HISTORIC DISTRICT REVIEW BOARD WORK SESSION AGENDA

Agenda Item: APPLICATION FOR AN ADDITION, HDRB #25-008, to consider an application for a Certificate of Appropriateness for the addition of a mudroom that will partially enclose an existing porch at the single-family residential building located at 631 Nash Street, Herndon, Virginia.

STAFF REPORT

PAXTON ADDITION
631 NASH STREET
HERNDON, VA 20170

Figure 1: 1976 aerial showing the former location of the subject dwelling on Van Buren Street. Note the absence of a wrap-around porch in this image. Source: Fairfax County JADE

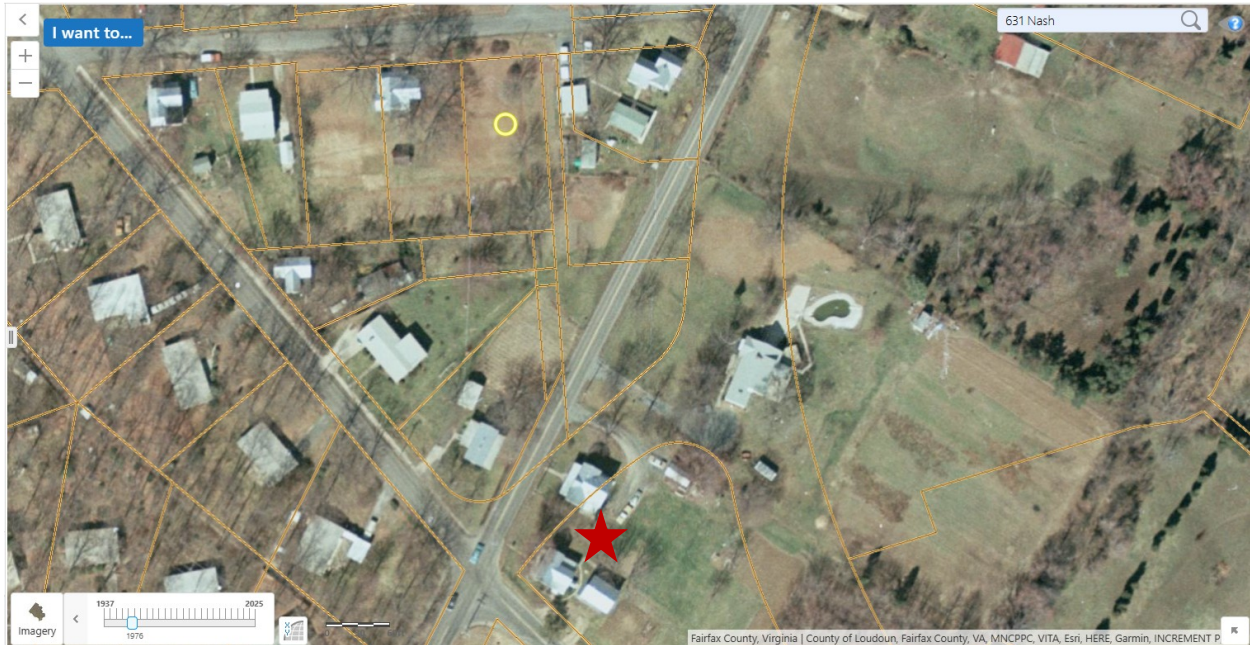
The house that currently sits at 631 Nash Street was originally sited to the south along Van Buren Street. The house was moved to its current location in 1989 to allow for the realignment of Van Buren Street (*Figures 1 and 2*). Historical aerial imagery shows that the house formerly had a front porch, but that it did not extend around the building in its previous location (*Figure 1*). It is therefore likely that the current wrap-around porch dates to the period when the building was moved to Nash Street (circa 1989). The wrap-around porch therefore is not a character-defining feature of the dwelling and has a higher tolerance for change than it would if it dated to the Herndon Historic District's period of significance.

SCALE	As indicated
SHEET TITLE	LEFT SIDE ELEVATIONS
SHEET NUMBER	A2.1

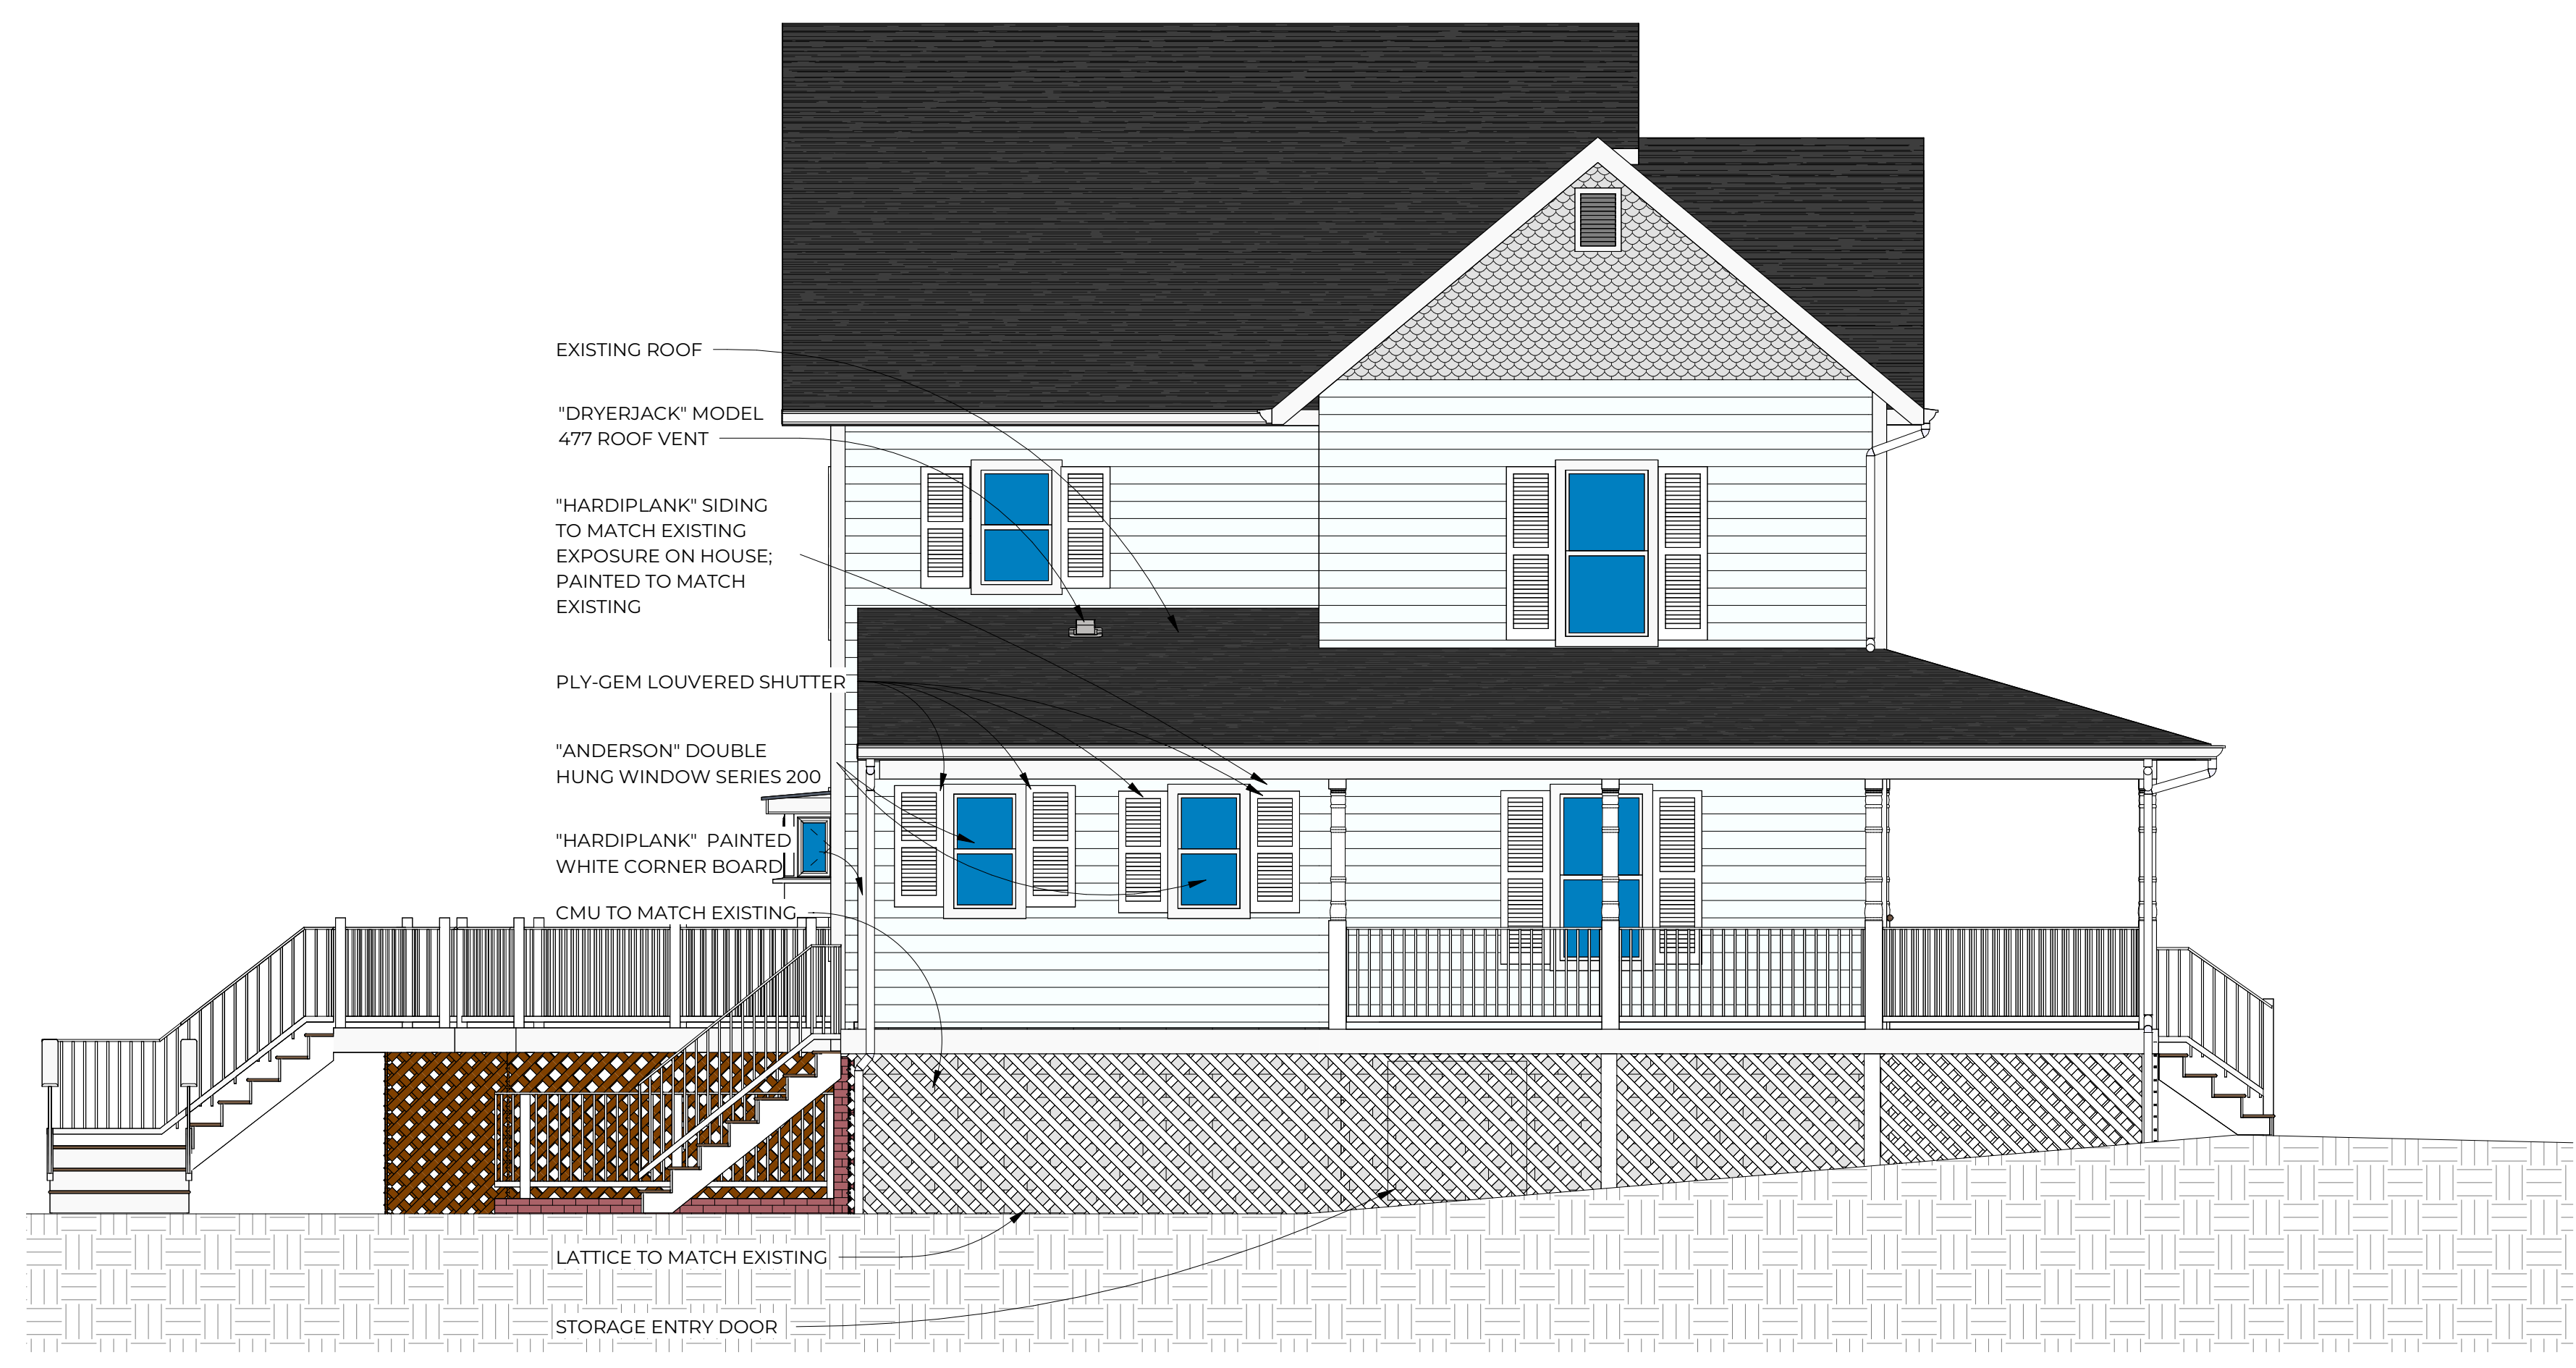
- Specifications for the storage entry door depicted on sheet A2.1.
- Further information is needed as to the material of the proposed Ply-Gem shutters to ensure that they are not vinyl. Solid vinyl is not appropriate for exterior materials within the Historic District Overlay.

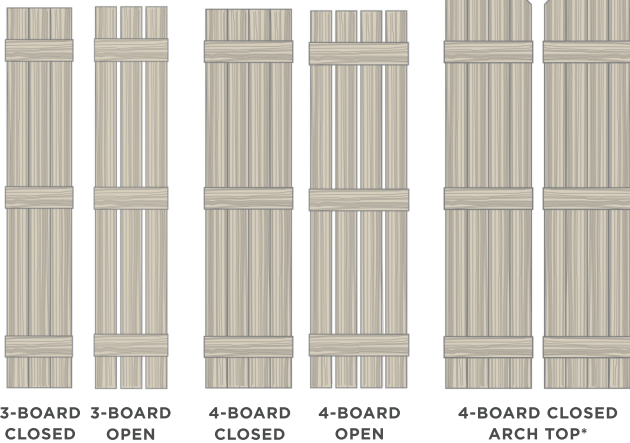
- o Will the proposed shutters match those that are currently on the dwelling in material and in design?
- Window specifications are not included in the current design package. Please include a manufacturer cutsheet that provides material details for the proposed window.
